7. CASE 21.127, 64 OAK STREET, Amos Fiske and Thomas Waterman House, c1876 (ARMORY)

Proposal: The scope of work proposed consists of Minor Alterations and includes

Arrow indicates 64 Oak Street

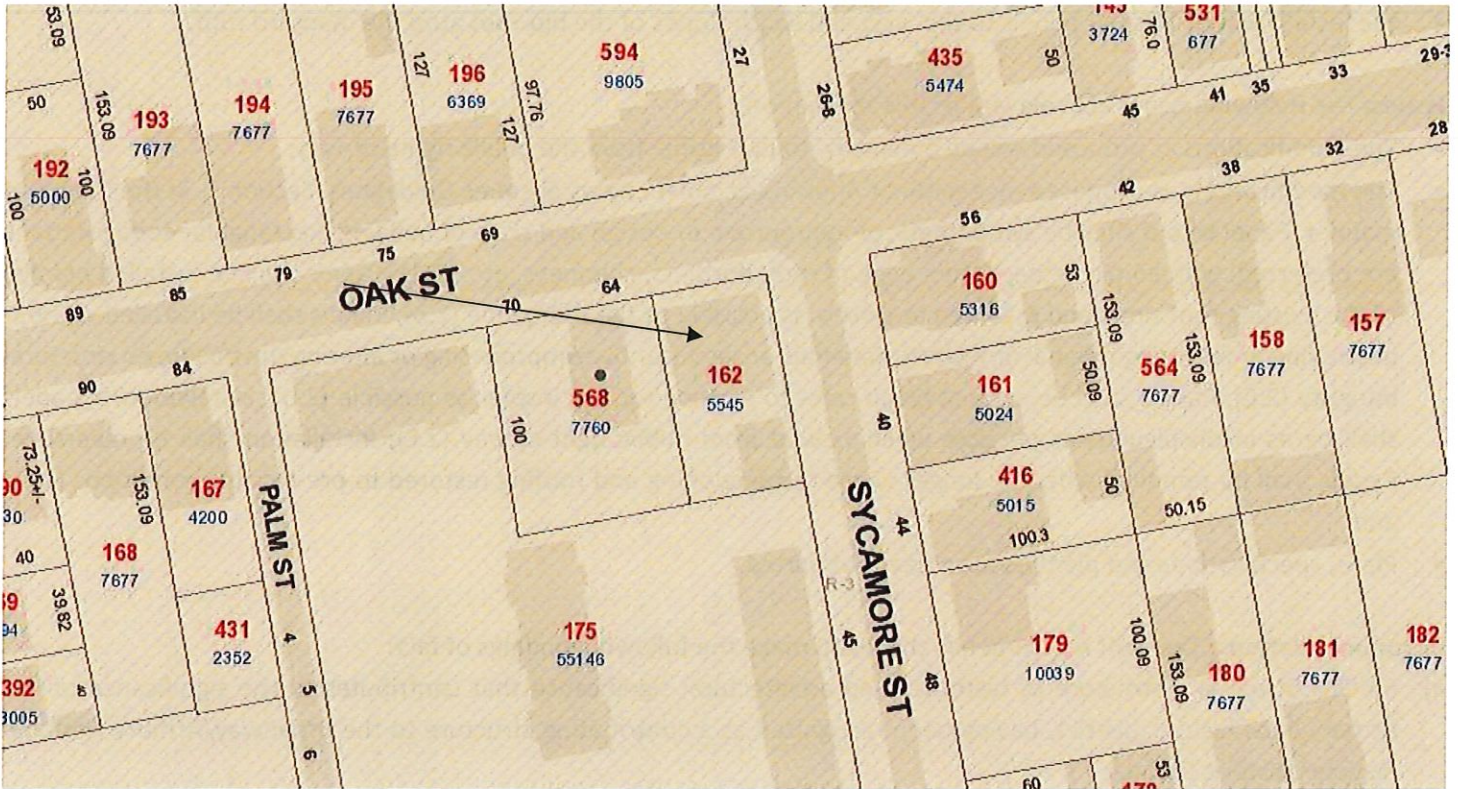
- The modifications as proposed will be minimally- to not-visible from the public rights-of-way;
- The modifications as proposed meets Minor Alterations: Solar Energy Systems Guidelines, Section 2, in the following manner: Panel layout shall be sympathetic or appropriate to design and scale of building. Rectangular configurations are preferred, with ample setback from edge of roof, dormers, chimneys, etc. (2.A); Panels shall be installed parallel to the existing roof slope and matched as closely as possible to the roof plane (2.B); Panels shall be installed without destroying or replacing original or historic materials or significantly compromising or altering the building's structural integrity (2.C); Panels shall be compatible in color to existing roofing insofar as possible (2.D); Installation of panels shall be as inconspicuous as possible when viewed from public right-of-way (2.E); Installation shall be reversible. Panels shall be removed when no longer viable or functioning and roofing restored to pre-existing conditions (2.F); and,

Staff recommends a motion be made stating that: The application is considered complete. 64 Oak Street is a structure of historical and architectural significance that contributes to the significance of the Armory local historic district, having been recognized as a contributing structure to the Broadway/Armory National Register Historic District. The Commission grants Final Approval of the proposal as submitted as the proposed alteration is appropriate having determined that the proposed alteration does not destroy the historic character of the property or the district and are historically and architecturally compatible with the property and district as the proposed alteration meets Minor Alterations: Solar Energy Systems Guidelines, Section 2, is reversible and be minimally- to not-visible from the public rights-of-way, and the recommendations in the staff report, with staff to review any additional required details.
